ADA Curb Ramp New Construction Inspection Form (Perpendicular)

Nw 293rd

23885.56

NW Keenon

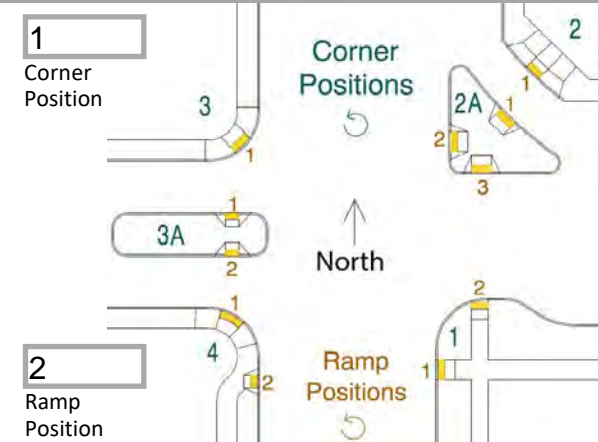
Running Slope 1

8.4

☒

Slope X

2.7

☒

Control joint center of TS
